COPLEY TOWNSHIP ARCHITECTURAL REVIEW BOARD

January 5, 2026

17
18
19 Case #: ARB202601
20 Applicant: Jeremy Simmons
21 On Behalf of: Graves Lumber Company
22 Landowners: Graves Lumber Co/Buy Rite/30/30 Corp Ltd/Buy Rite Lumber
23 Property Address: 1315 S Cleveland Massillon Road
24 Property Location: PPN 1508656
25 Zoning District: Industrial (I)
26 Proposal: Major Site Plan-Unenclosed Accessory Building
27

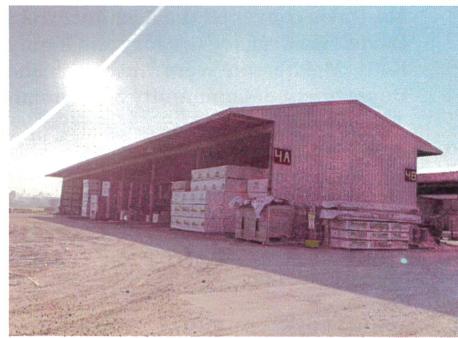
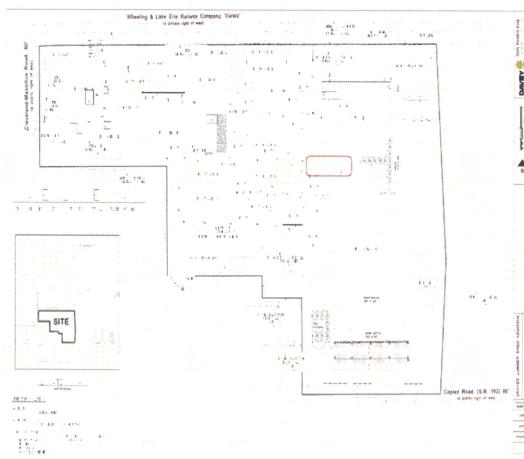
The Fire Department requires drivable vehicle access to all sides of the buildings. The building shall be designed to the most current Ohio building and fire codes for its designated use group.

- The new underground storage completed in 2024 was designed to address the additional impervious area for structures on the east side of the existing gravel access road.
- A grading permit prior to construction, primarily for purposes of showing the roof drain/down spout locations.

Mr. Grigson asked if the building would be sprinkled.

Mr. Simmons stated that the building was under 12,000 square feet and did not require a sprinkler system. However, there are sufficient hydrants onsite for the entire property.

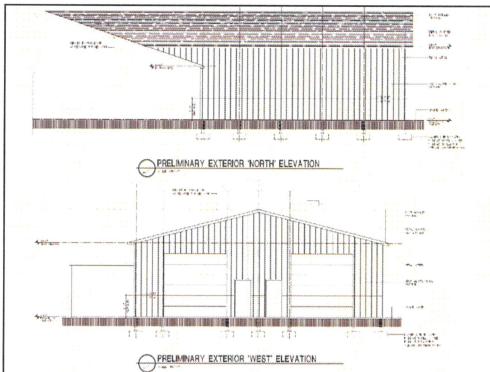
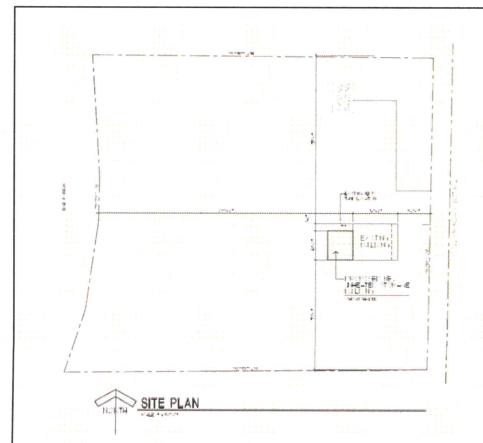
SUMMIT SOIL & WATER CONSERVATION DISTRICT*Floodplain present. A variance will be required as the floodplain is connected to the Riparian.*

Per Staff Review, a variance for any improvement on this parcel will be required as the entire parcel is encompassed by the floodplain.

Mr. Gregory asked what type of material would be used for the flooring.

Mr. Gregory asked if changing the materials would change surface water review.

Mr. Kiehl stated they are planning to keep it gravel, however, if expenses allow they would like to concrete it in the future. The immediate goal is to get equipment out of the weather and under shelter.

Ms. Gfroerer stated yes, concrete produces a higher run off calculation than gravel. Mr. Kiehl could work with Summit County now to plan for future installation of concrete so that he is aware should anything additional be required to change the flooring material.

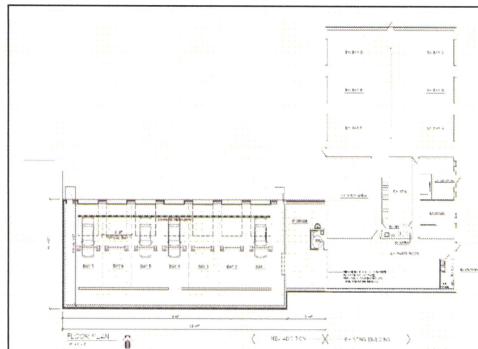
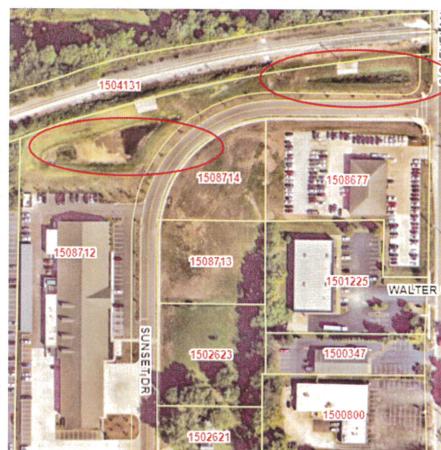
1 ○ Recommend removal of 1 space located at the entrance on the south side.
2 This space blocks the viewshed of cars entering and existing.
3

13 ***Request: Accept Sunset Drive plantings installed on the north side of Sunset Drive to***
14 ***satisfy requirement for building façade landscaping***

21 ***Request: Reduce required perimeter landscaping along western property line from***
22 ***10' to 6'.***

23 ***Waive perimeter landscaping requirement for previously installed parking spaces***
24 ***(2024).***

34 ***Request: Waive landscape island requirement for previously installed parking spaces.***

39 *Stormwater improvements constructed*
40 *with the Sunset Drive Extension project*
41 *was not designed to handle flow from the*
42 *Autobahn site. A pre vs. post analysis will*
43 *be required for the Autobahn*
44 *improvements. The new impervious*
45 *appears to be relatively small, but an*
46 *analysis of existing gravel compared to*
47 *proposed concrete and building may show*
48 *a significant increase in runoff from the*
49 *site. Per the Urban Hydrology for Small*
50 *Watersheds Manual from the USDA, the*
51 *Curve Number for gravel ranges from 85 to*
52 *91, depending on Soil Group*
53 *Classification. Asphalt, concrete and rooftops/buildings Curve Number is 98, regardless of*
54 *Soil Group. This may result in a Critical Storm of 10 or 25-year design storm.*

30
31 **Mr. Gregory stated that the applicant would need to find a suitable substitution for**
32 **the burning bush proposed along the western property line as this is an invasive**
33 **species. Mr. Smith will present alternatives to Mr. Gfroerer to be reviewed by Ms.**
34 **Graf.**

47
48 1. **Section 14.06 Building Façade Landscaping-Rationale accept Sunset Drive**
49 **deciduous tree plantings installed by Copley Township on the north side of**
50 **Sunset Drive**

51
52 2. **Section 14.08 C. Parking lot landscape perimeter. Reduction in the required**
53 **perimeter landscape along the western property line from 10' to 6'. -**
54 **Rationale-Location of building and length of parking spaces do not permit 10'.**
55 **Applicant also owns adjacent lot to the west**

56
57 3. **Section 14.08 C. Parking lot landscape perimeter. No additional landscape**
58 **required along S Cleveland Massillon Road. Rationale- Future installation of**
59 **landscape and sidewalk by Copley Township**

1 4. Section 14.08 B. One landscape island for every 10 spaces. *Rationale-*
 2 *Majority of lot is not used for customer parking. Should use change and spaces*
 3 *are now used for customer parking, landscape islands will be required.*

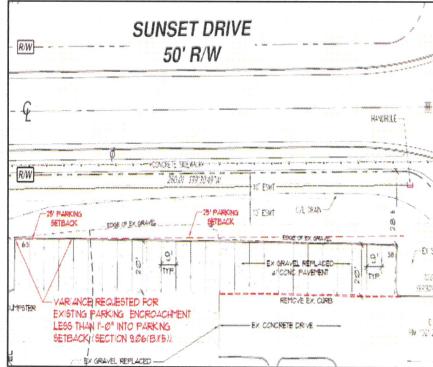
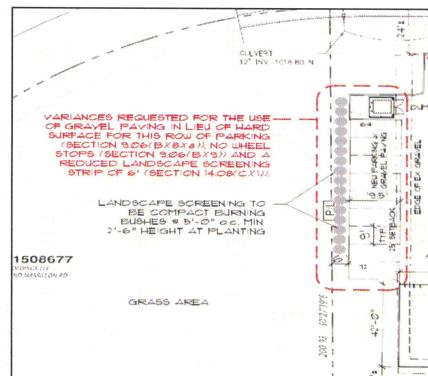
14 **Request: Variance to encroach into the**
15 **25' front yard setback by 1'**

23 **Request: Variance to maintain gravel**
24 **surface for parking area along the**
25 **western property line**

34 **Request: Relief from section 9.06 9. No wheel stops**

11 1. Section 9.06 5. Variance to encroach 1' into the required 25' front yard
 12 setback along Sunset Drive
 13 2. Section 9.06 B. a. Variance to maintain gravel surface for parking area along
 14 the western property line
 15 3. Section 9.06 9. Relief from requirement to utilize wheel stops for parking
 16 area along western property line

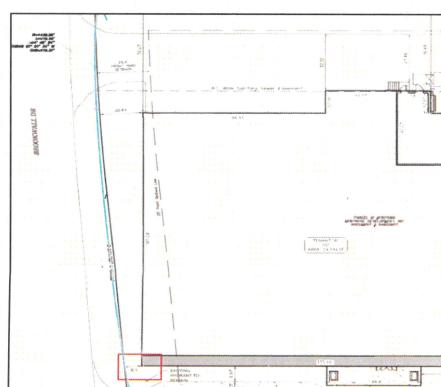
- 25' Minimum Front Yard Setback (NORTH)
○ **8.1' Non-conforming**

52 Variance Rationale: The front yard
53 setback is pre-existing and created due to
54 the expanded right of way for the
55 installation of Brookwall Drive. This
56 variance will correct the non-conforming
57 setback.

49
50 **Ms. Davis called for a motion. Ms. Davis motioned to approve the applicants site plan**
51 **conditioned upon satisfying all agency requirements and receipt of the variance**
52 **required for the front yard setback. Mr. Gregory seconded. Ms. Davis asked for a**
53 **vote. All in favor. Motion carried.**
